No: 6-GJC050/2020-BHO

Sub : Re-diversion of 9.90 ha Protected/ Reserve Forest land for construction of Ambaji bypass (Km. 2/950 to Km. 5/150) on Himmatnagar-Kheroj-Ambaji-Aburaod SH-9 in favour of Executive Engineer, R&B Division (State) Palanpur in Banaskantha District of Gujarat.

41<sup>st</sup> Meeting of Regional Empowered Committee, Bhopal  
Dt. 24/12/2019

✓ Proposal for diversion of 23.178 ha (13.278 ha RF + 9.90 ha Re-diversion) Section-4 & Reserved Forest land for construction of Ambaji bypass road Km. 0/00 to Km. 51/150 on Himmatnagar-Kheroj-Ambaji-Abu road SH-9 in favour of Executive Engineer, R&B Division (State) in Banaskantha District of Gujarat (6-GJC054/2019-BHO).

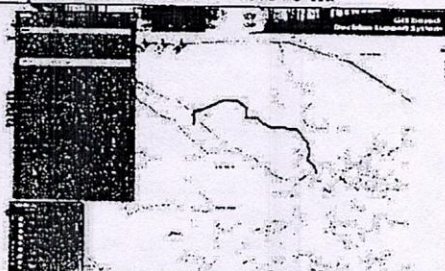
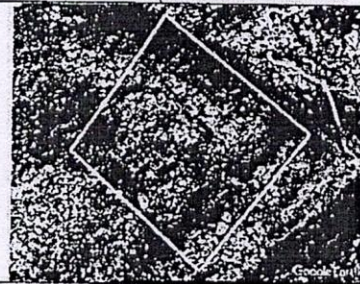
- a. The proposal is in two parts i.e 13.278 ha RF for diversion and 9.90 ha re-diversion
- b. The 9.90 ha re-diversion, the a chunk of forest land was given to GMDC for mining and out of which for 9.90 ha forest land GMDC had given NOC to R&B Department, Govt. of Gujarat for road construction.
- c. The status of the forest clearance give to GMDC is not submitted.

- d. There is standard condition in all the cases "The layout plan of the proposal shall not be changed without prior approval of Central Government". Thus required changes needs to approved form the Govt. of India.

- e. The proposal attracts Para 1.2 (iv) of FCA Handbook 2019: Violation on account of change of land use in the approved mining plan.
- f. Details regarding exploration of alternatives and the suitability of present alternative have been given on a map & comparative analysis not submitted/ uploaded.

- g. The CWLW letter dt. 30/03/2016 is for 1.908 ha out of 23.178 ha, however, detailed break out the project in the Protected area, eco-sensitive zone area and outside protected area long with detailed CWLW comments for eco-sensitive zone shall be submitted.

- h. The CA scheme of Model No 3 with 1111/ ha on non-forest land is submitted which is not in accordance to the Para 2.8 (iii) of FCA Handbook 2019. Thus, site specific CA scheme as per the Para 2.8 (iii) of FCA Handbook 2019 is required.

1. The proposal is in two parts i.e 13.278 ha RF for diversion and 9.90 ha re-diversion, thus the status of the forest clearance given to GMDC and copy of Stage-II approval shall be submitted.

2. The CWLW letter dt. 30/03/2016 is for 1.908 ha out of 23.178 ha, however, detailed break up of the project in the protected area, eco-sensitive zone area and outside protected area long with detailed CWLW comments for eco-sensitive zone shall be submitted.

3. Details regarding exploration of alternatives and the suitability of present alternative have been given on a map & comparative analysis shall be submitted/ uploaded.

4. The CA scheme of Model No 3 with 1111/ ha on non-forest land is submitted which is not in accordance to the Para 2.8 (iii) of FCA Handbook 2019. Thus, site specific CA scheme as per the Para 2.8 (iii) of FCA Handbook 2019 and shall also include following points:

6. As the GMDC project was approved form the MoEFCC, New Delhi, thus the 9.90 ha re-diversion proposal shall be submitted to MoEFCC for approval.
